Work Order ID 139296

Item Name: Quick Release Heli-Utility-Basket™ Long, HD Lid, Spacepod™/Squirrel Cheek Comp.

**TO AMEND INSTALLATION INSTRUCTIONS D350-607-3 Rev.D,
INSTALLATION INSTRUCTIONS D350-607-4 Rev. C AND
INSTRUCTIONS FOR CONTINUED AIRWORTHINESS ICA-D350-607 REV. 6
REF TCCA STC: SH94-14
REF FAA STC: SR00213NY
REF EASA STC: EASA.10016996
REF BRAZILIAN STC: 2007S03-03/-04/-05/-06**

A	NEW ISSUE	AJS	14.05.16
REV.	DESCRIPTION		BY DATE
DESIGN	AJS	DART AEROSPACE LTD HAWKESBURY, ONTARIO, CANADA	
DRAWN	AJS		
CHECKED	<i>[Signature]</i>	DRAWING NO.	REV. A
MFG. APPR.	N/A	DSI 9699	SHEET 1 OF 2
APPROVED	<i>[Signature]</i>	TITLE	SCALE
DE APPR.	<i>[Signature]</i>	LUG REPLACEMENT	NTS
DATE	14.05.16	COPYRIGHT © 2014 BY DART AEROSPACE LTD THIS DOCUMENT IS PRIVATE AND CONFIDENTIAL AND IS SUPPLIED ON THE EXPRESS CONDITION THAT IT IS NOT TO BE USED FOR ANY PURPOSE OR COPIED OR COMMUNICATED TO ANY OTHER PERSON WITHOUT WRITTEN PERMISSION FROM DART AEROSPACE LTD

FIGURE 1: INSTALLATION OF D4775-041 FWD STRUT

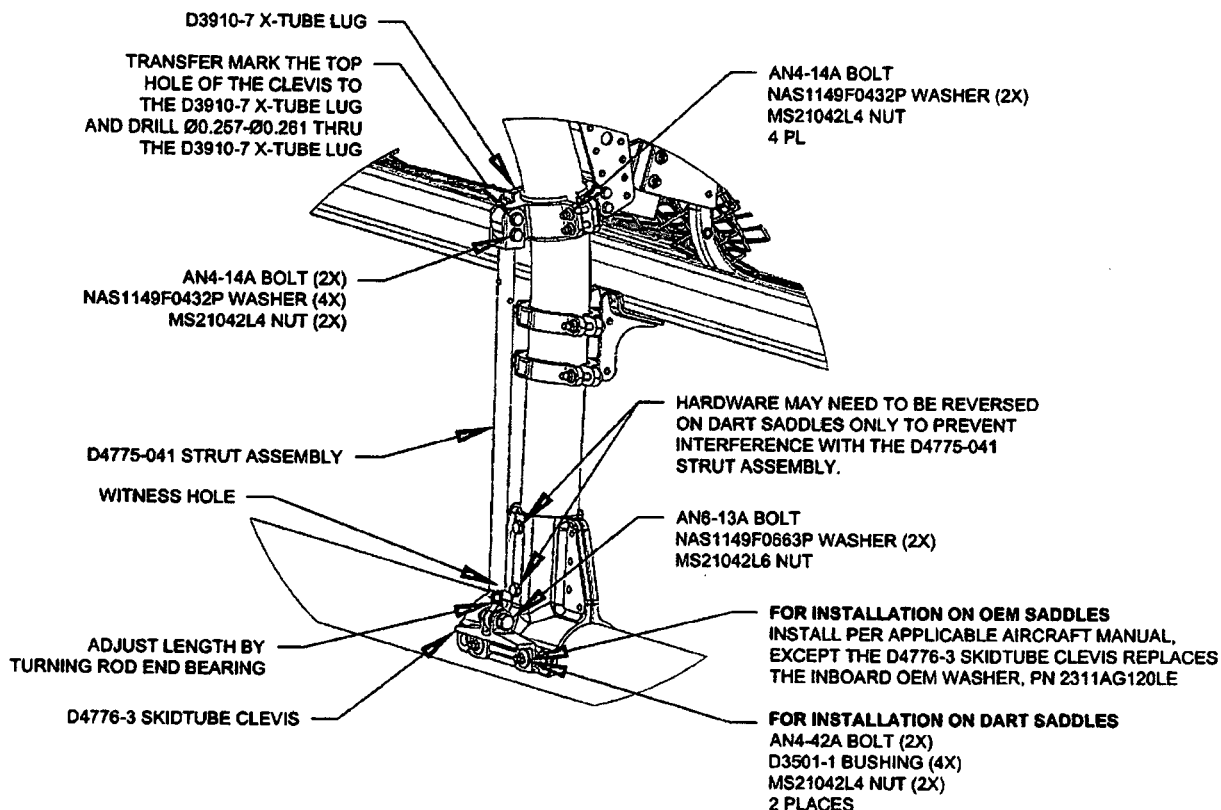
- 3.1 Substitute the Forward Lower D3910-5 X-Tube Lug with the D3910-7 X-Tube Lug as shown in Figure 1.
- 3.2 Install the forward D4775-041 Strut Assembly. Transfer mark from the upper hole on the clevis of the D4775-041 Strut Assembly to the D3910-7 X-tube Lug and drill thru the lug $\varnothing 0.257$ - $\varnothing 0.261$ as shown in Figure 1. Touch up chemical conversion coating per MIL-DTL-5541. Check the witness holes located at the bottom end of the D4775-041 Strut Assemblies to ensure that the thread from the rod end extends past the witness hole.
Torque MS21042L4/-4 nuts to 50-70 in-lbs (5.7-7.9 N-m). Torque MS21042L6/-6 nuts to 160-190 in-lbs (18.1-21.5 N-m).
- 3.3 Complete the installation in accordance with Installation Instructions D350-607-3 Rev. D or D350-607-4 Rev. C.
